2AM-MEL1631 Water Licence Amendment

Final Written Statement Responses

Submitted to:
Nunavut Water Board

Submitted by:
Agnico Eagle Mines Limited – Meliadine Division

Figure NEW-TC-7-1: Report Card on Health of Meliadine Lake – Water Quality

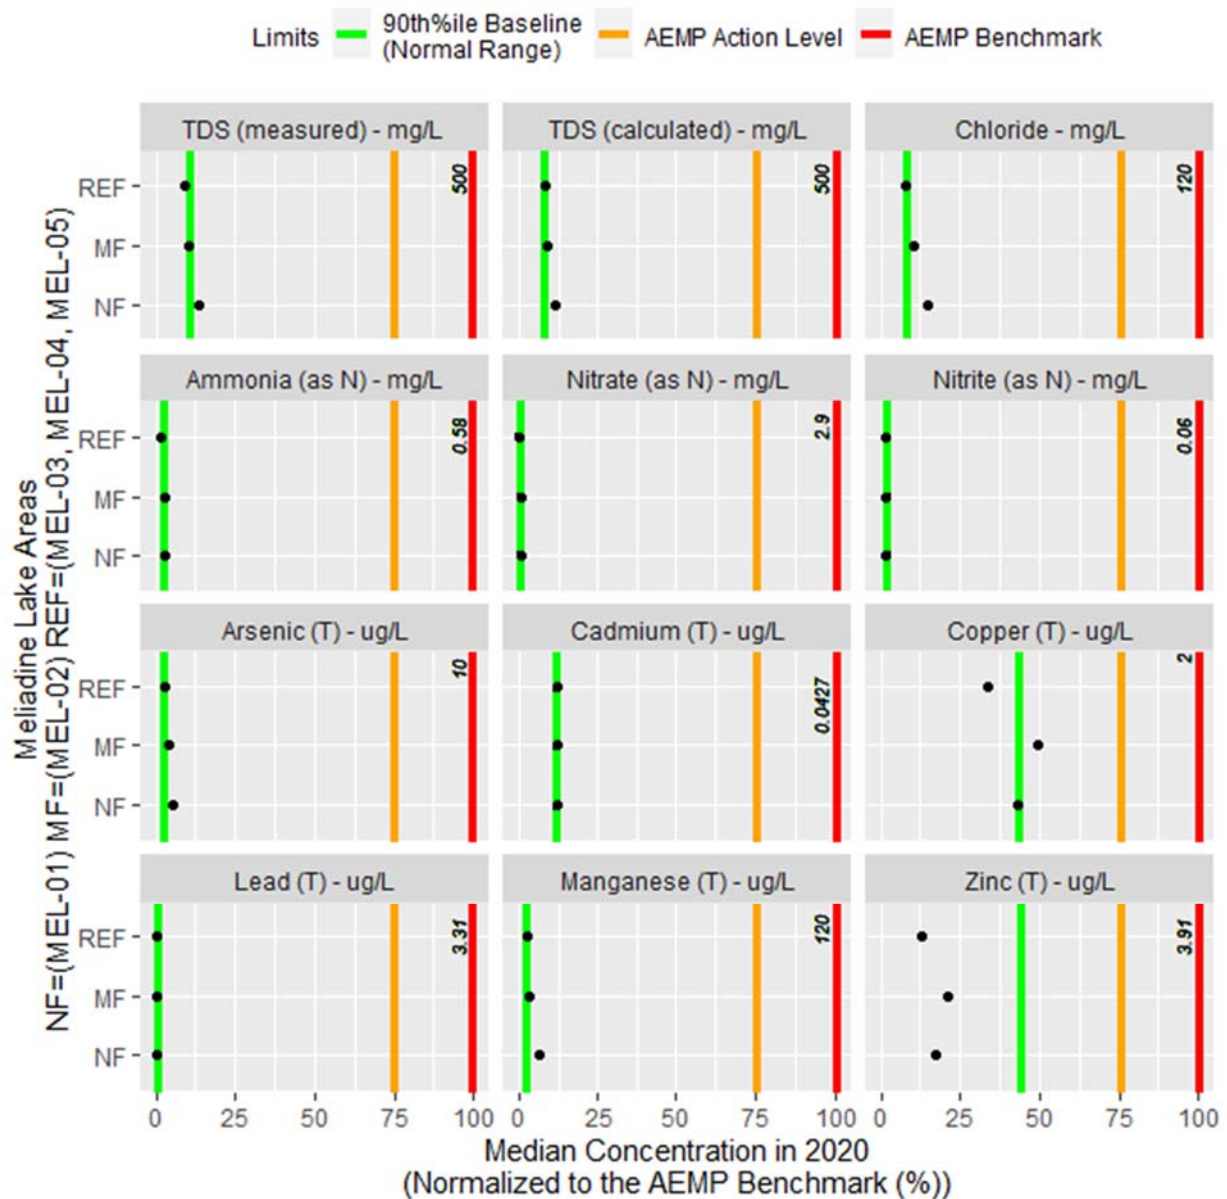
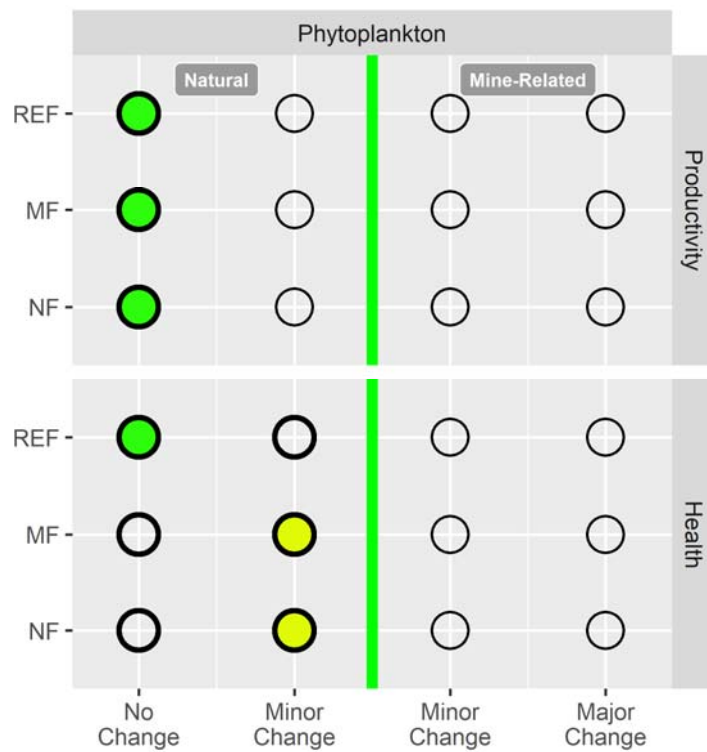
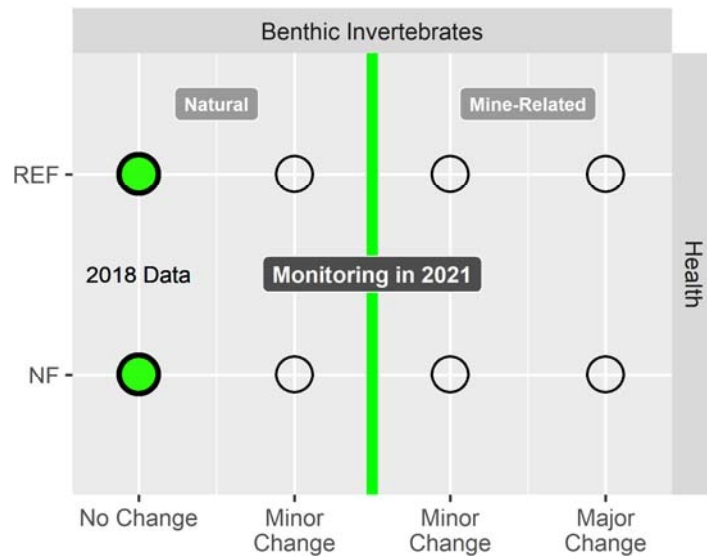
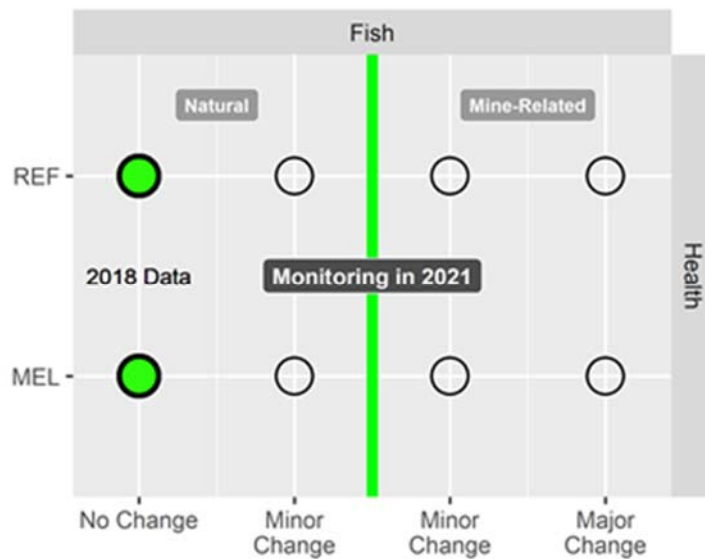
We appreciate Agnico Eagle's clarification regarding the overall purpose of the waterlines as well as the groundwater storage volumes provided through Tiriganiaq-2, SP1 and SP4. However, Agnico Eagle has not clarified how excess saline groundwater stored in Tiriganiaq-2 will be handled under the AMP until the waterlines are available and Tiriganiaq-2 is dewatered.

The AEMP is an integrated monitoring program designed to assess whether activities at the mine are causing changes in the aquatic environment. The AEMP was designed in consultation with the community, regulators, and other stakeholders. The AEMP incorporates Inuit Qaujimajatuqangit, including Traditional Ecological Knowledge, and western science to assess water quality and the health of Meliadine Lake. Components monitoring under the AEMP include water quality, plankton, sediment quality, benthic invertebrates, and fish.

Water quality results are compared to background concentrations (referred to as the normal range), and guidelines for protection of aquatic life and guidelines for protection of drinking water (referred to as AEMP Benchmarks). Results from the 2020 monitoring in comparison to the normal range and benchmarks are presented in Figure NEW-TC-7-1. As the figure plots illustrate, concentrations of substances in the water from Meliadine Lake (in the near-field area around the diffuser, downstream in the mid-field area, and further downstream in the reference areas of the lake) are a fraction of the AEMP Benchmarks and a fraction of the AEMP low action levels (75% of the AEMP Benchmark) for adaptive management.

The phytoplankton community in the lake is healthy, but the community in the near-field area is naturally different than the community in other areas of Meliadine Lake (Figure NEW-TC-7-2). Results of the 2018 benthic invertebrate study confirmed that the diversity and abundance of the benthic invertebrate community is similar in different areas of the lake and the structure and ecological function of the community is not being affected by the Mine (Figure NEW-TC-7-3). Results of the 2018 fish program confirmed that survival, growth, reproduction, or energy use of fish living at the near-field area were not affected by the Mine (Figure NEW-TC-7-4). Toxicity testing conducted in 2020 confirmed that water in the near-field area is safe for benthic invertebrates and fish.
